CITY OF ALBUQUERQUE

RE: **Oso Bio Syringe Line**
Grading Plan for Building Permit 4401 Alexander Blvd
Engineer's Stamp Date 12/22/2017 Disapproved
Hydrology File: F16D003B1

**RE: Oso Bio Syringe Line
Grading Plan for Building Permit 4401 Alexander Blvd
Hydrology File: F16D003B1**

XREF FILE(S): _____ DRAWING NUMBER: **C1.0**

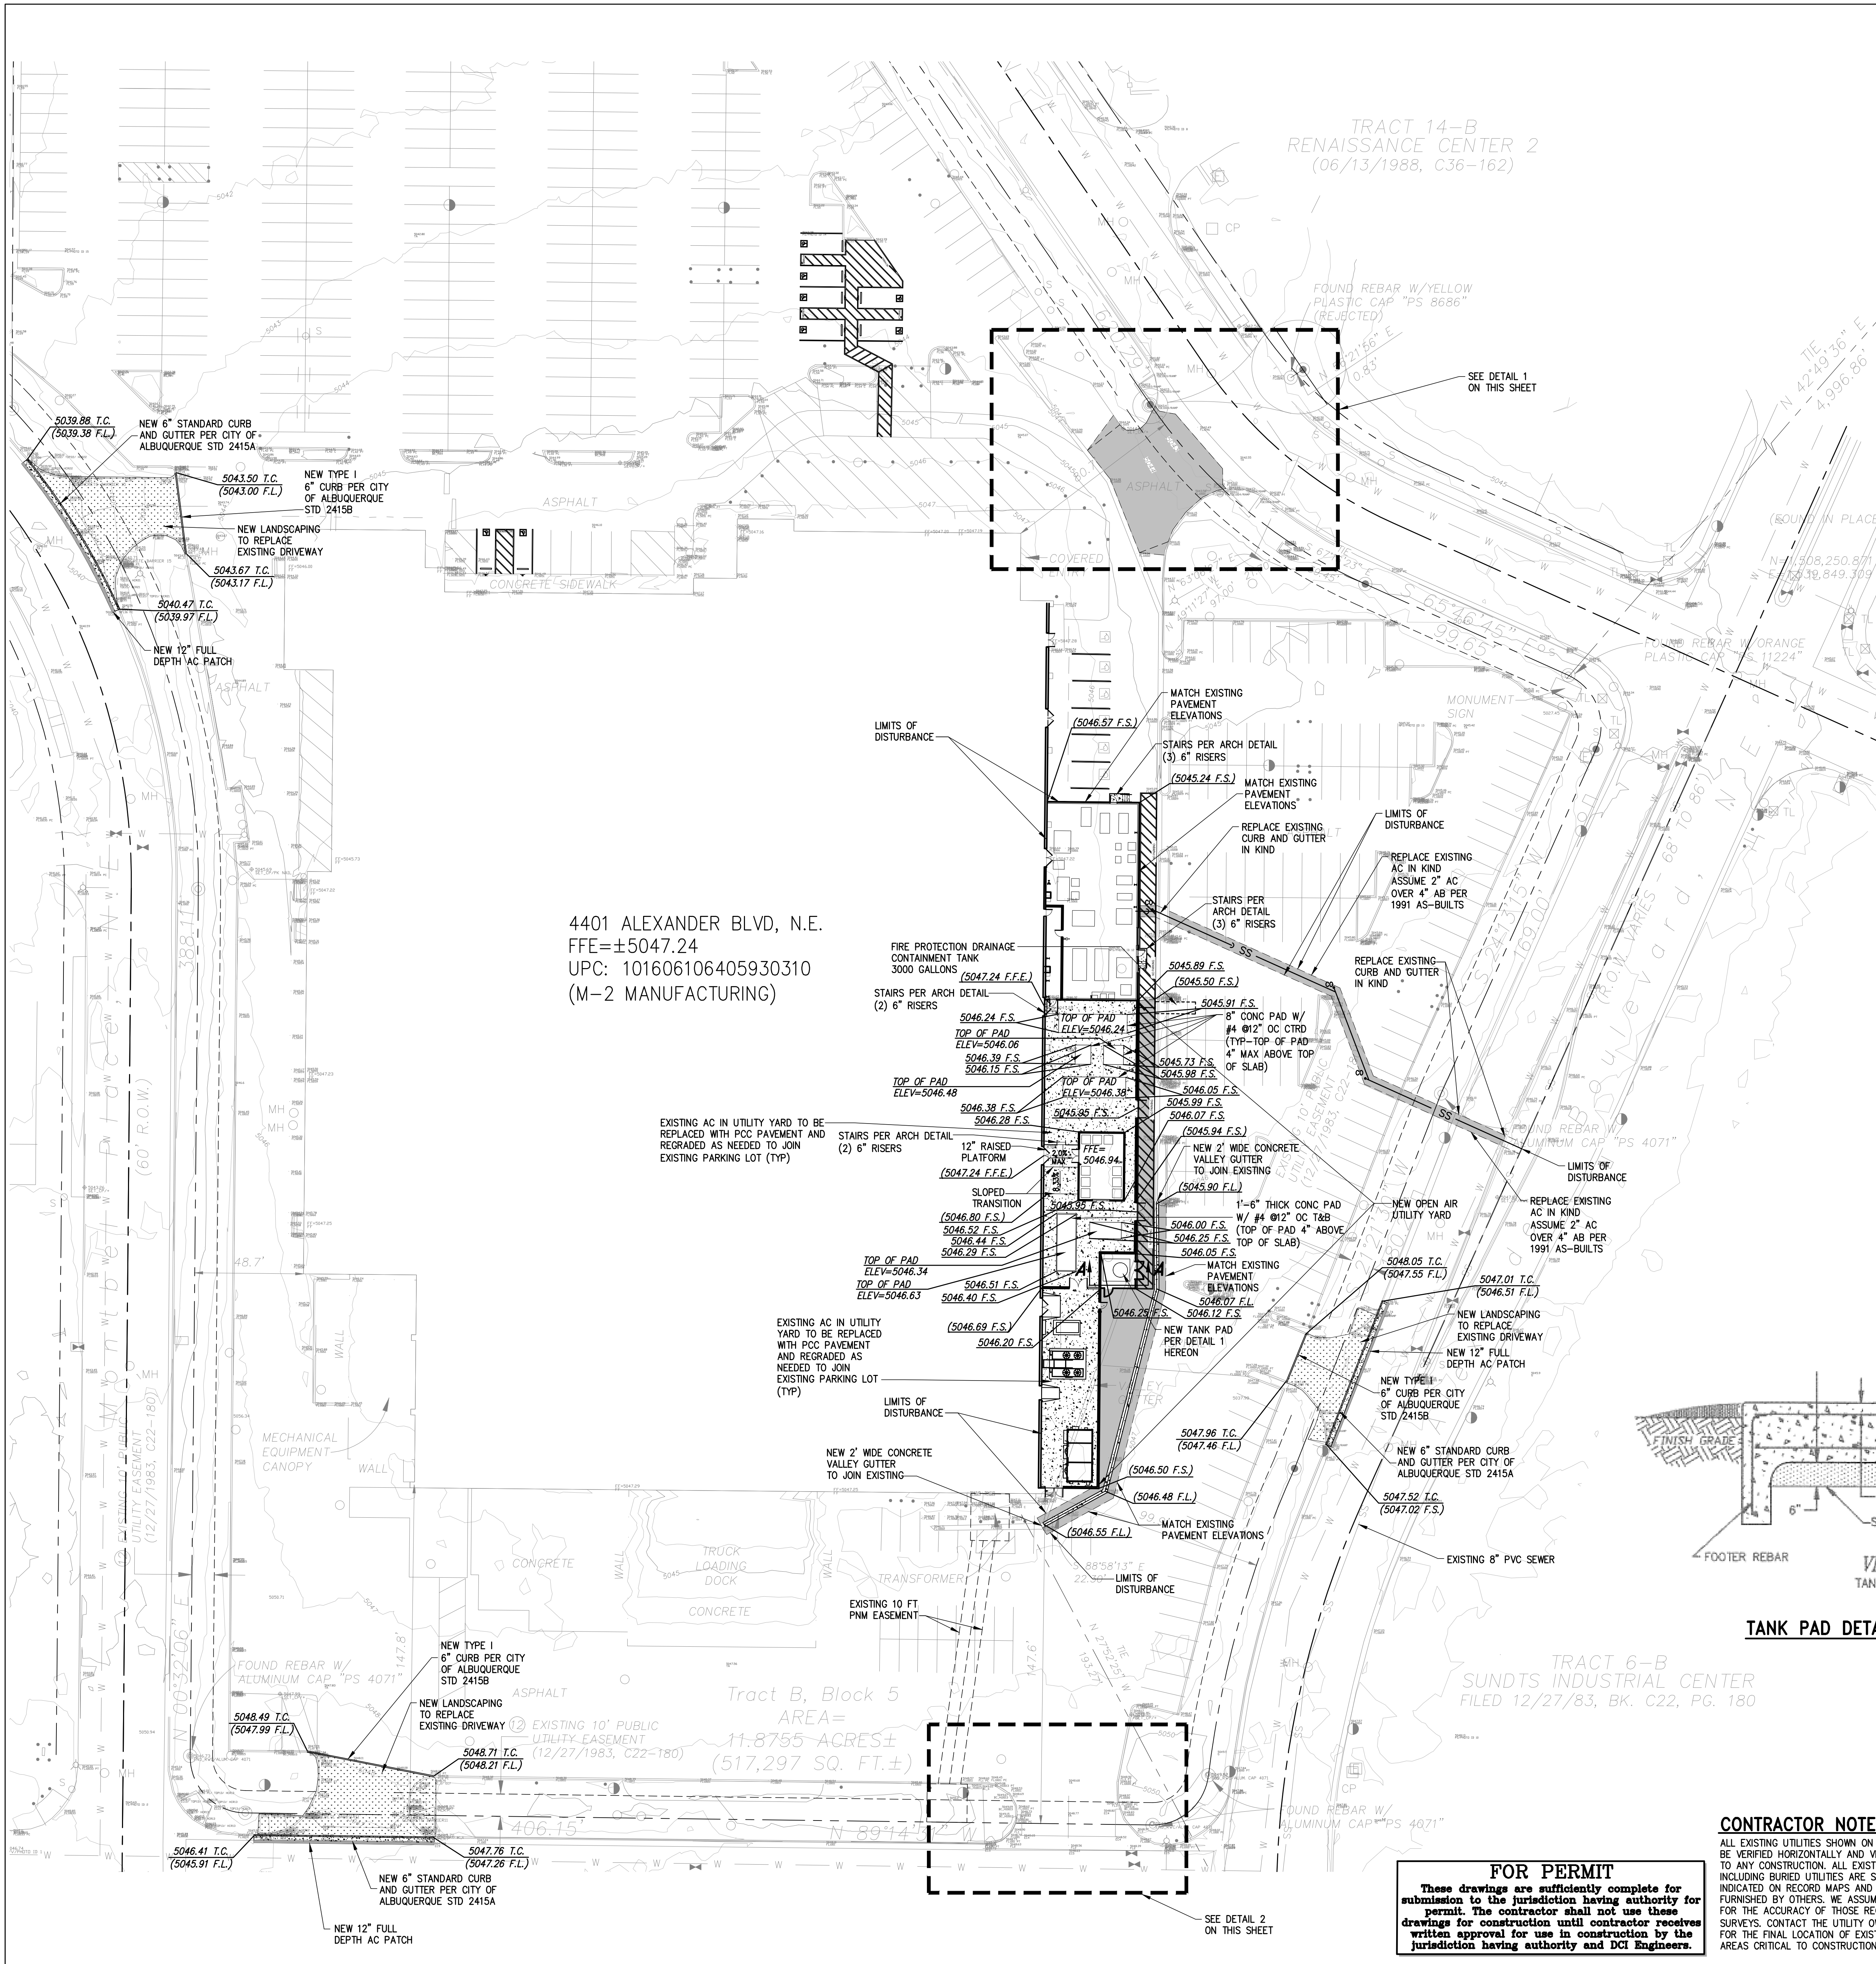
4. Sheet C 1.0 shows most of the driveways to be closed but one additional driveway on the north end of the site needs to be closed and must be shown on the plans. It shows up on sheet C1.3. Since pond reconstruction may impact the right of way, notes should be added to sheet C1.3 also, stating "An excavation permit will be required before beginning any work within City Right-Of-Way". Another note should state "Two working days prior to any excavation, the contractor must contact New Mexico One Call, dial "811" [or (505) 260-1990] for the location of existing utilities. Prior to construction, the contractor shall excavate and verify the locations of all obstructions. Should a conflict exist, the contractor shall notify the engineer so that the conflict can be resolved with a minimum amount of delay."

ENGINEER DCI	ARCHITECT -	DESIGNER CSC	IPS PROJECT # CAD16088.01
DRAWN BY CSC	REVIEWED BY MHN	SCALE AS NOTED	CADD FILE NAME
XREF FILE(S)	DRAWING NUMBER C1.1

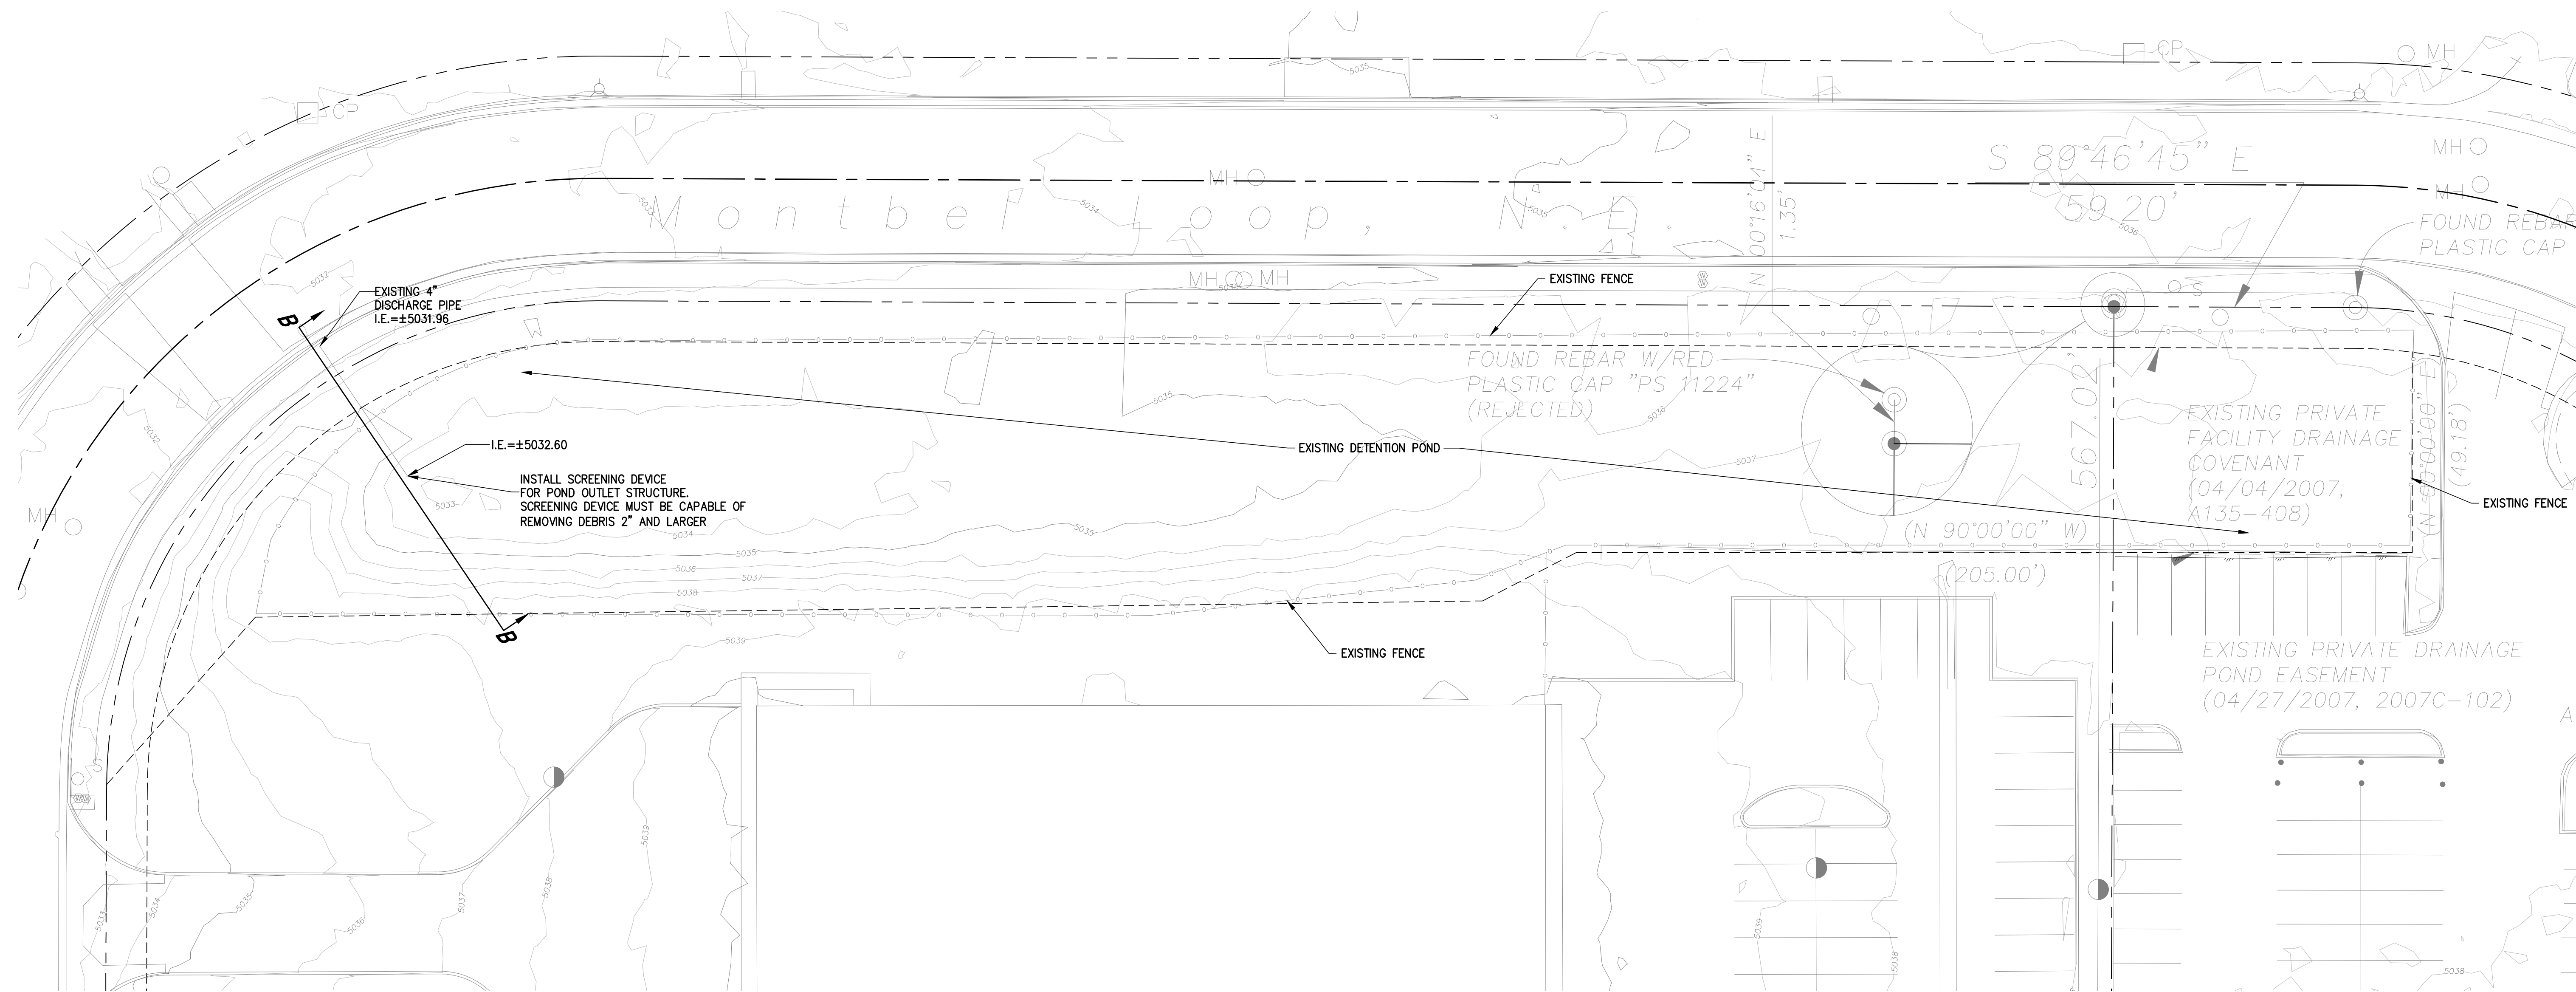
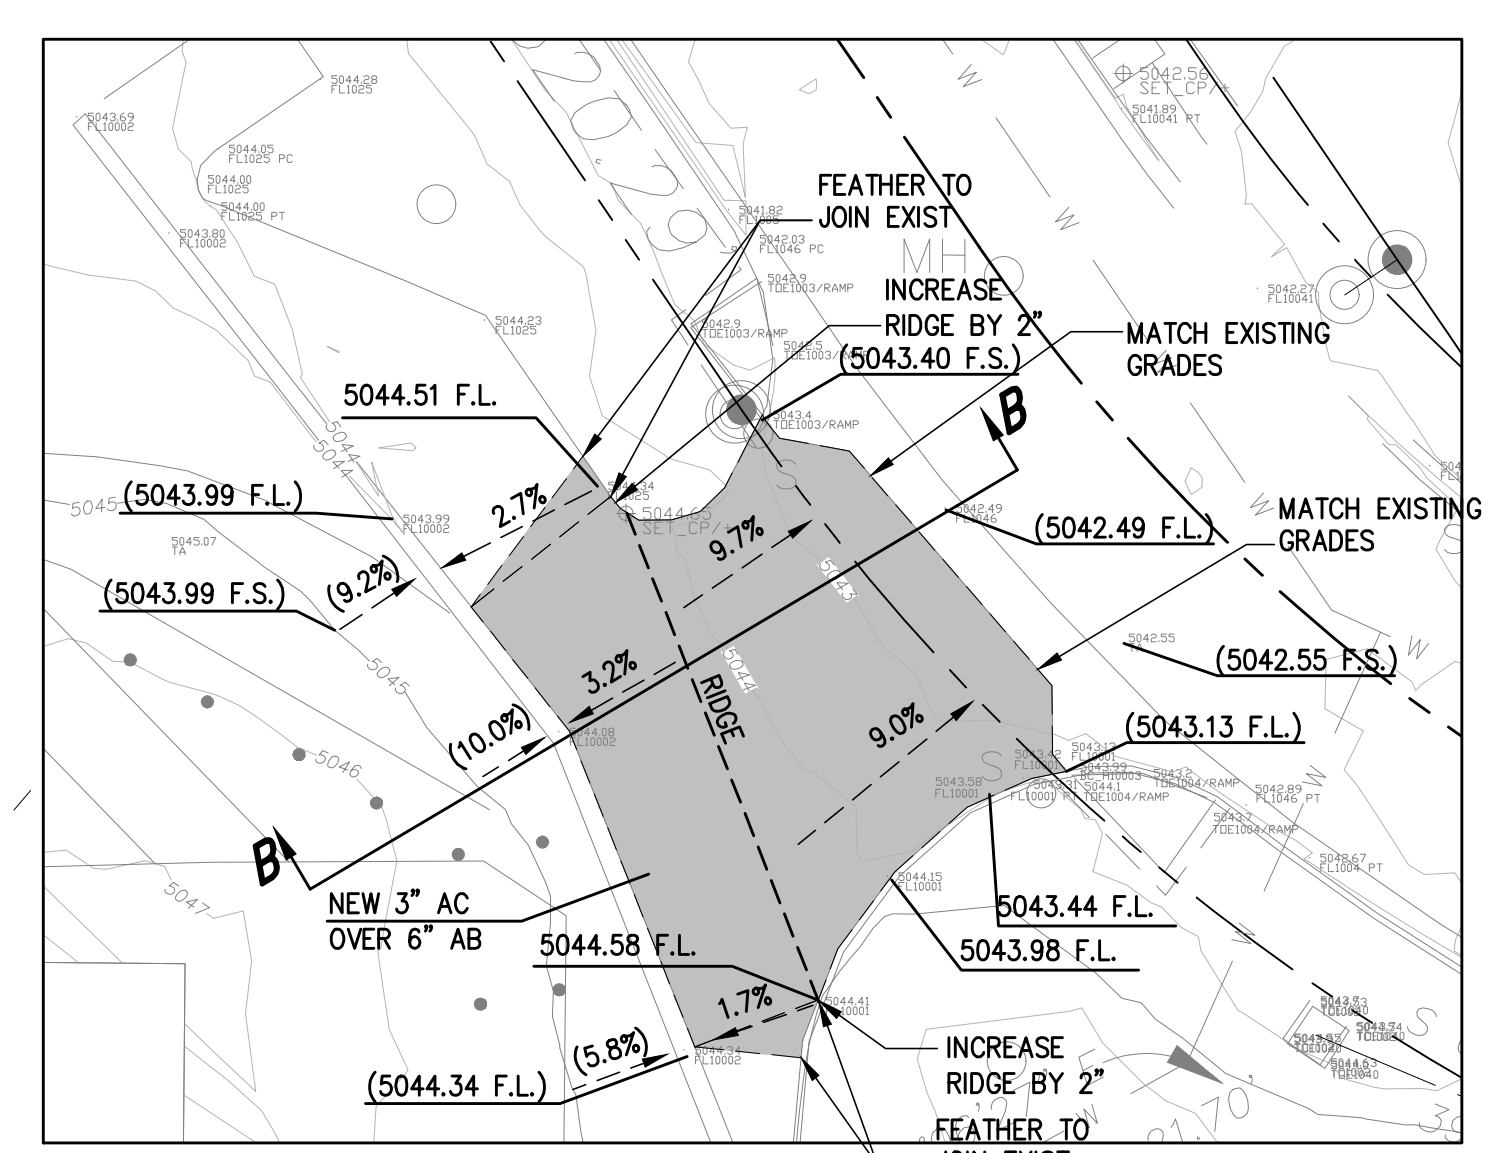
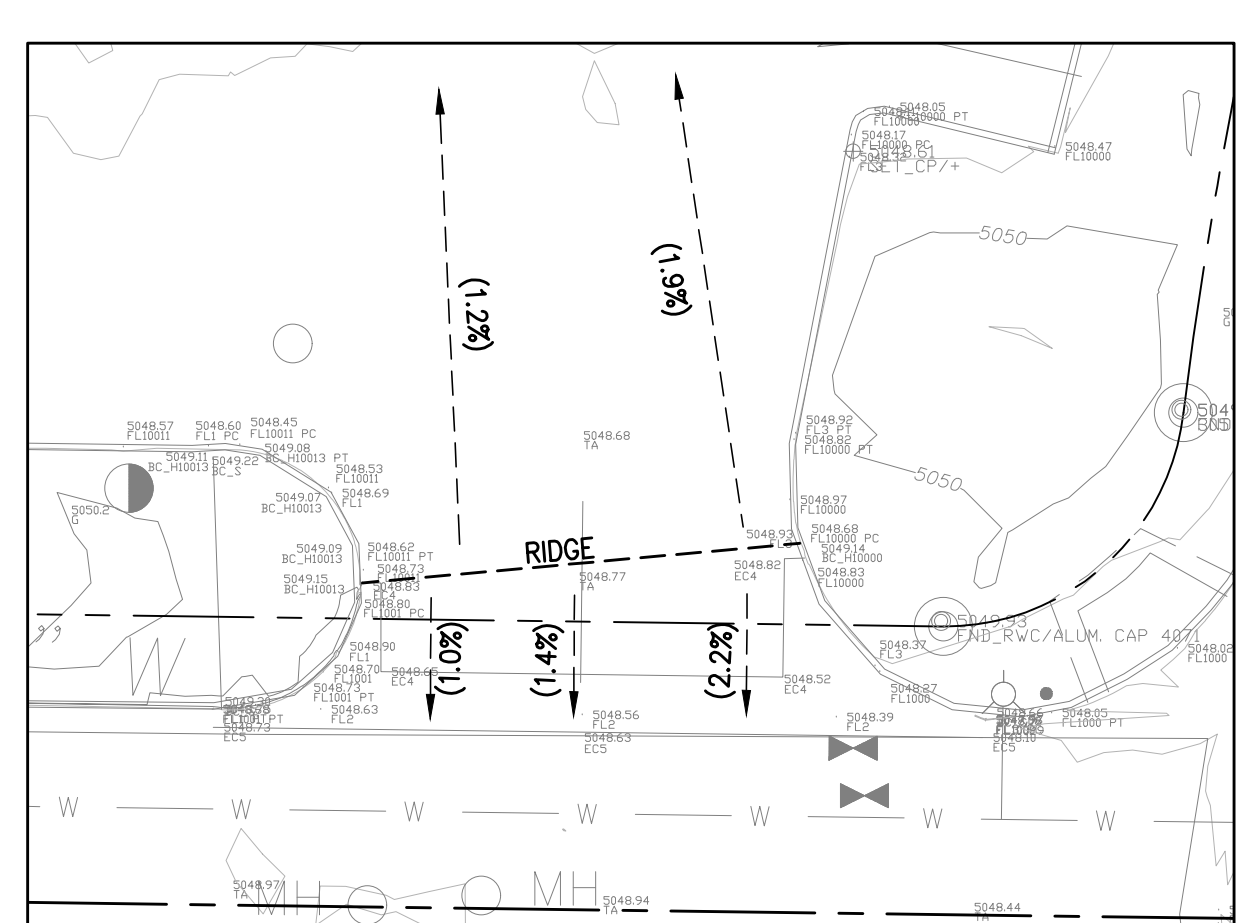
2. Only two driveways are being used, so the rest must be demolished. New Curb and Gutter must be shown on the grading plan across those entrances, along the street and parking lot, and the area between should be restored with landscaping. A note must be added to the G&D Plan stating “An excavation permit will be required before beginning any work within City Right-Of-Way”. Another note should state “Two working days prior to any excavation, the contractor must contact New Mexico One Call, dial “811” [or (505) 260-1990]] for the location of existing utilities. Prior to construction, the contractor shall excavate and verify the locations of all obstructions. Should a conflict exist, the contractor shall notify the engineer so that the conflict can be resolved with a minimum amount of delay.”

3. Normal depth calculations should be added to the supplemental report demonstrating that the onsite swale/valley gutter has capacity at the north driveway. More survey may be needed at the north driveway, and additional height should be added to the ridge to be certain that the drainage stays onsite.

Please see revised grading plan on sheet C1.1 for removal of existing unused driveways. Curb and gutter installation is called out at the existing driveway entrances and landscaping shall fill

in the areas of the removed driveways. Please see sheet C1.1 notes 3 and 4 for additional required notes.

Hydraulic capacity calculations for the existing valley gutter adjacent to the north driveway have been provided in Attachment 4 of the Drainage Narrative. Analyzing the existing conditions, the valley gutter has a capacity of 4.49 cfs while the design 10-year storm generates a flow of 6.05 cfs. To address this, the ridgeline of the driveway was increased by 2" which increases the hydraulic capacity to 12.28 cfs. Construction callouts and grading for this upgrade are shown in the Exhibits in Attachment 4 of the Drainage Narrative as well as Detail 1 on sheet C1.1.
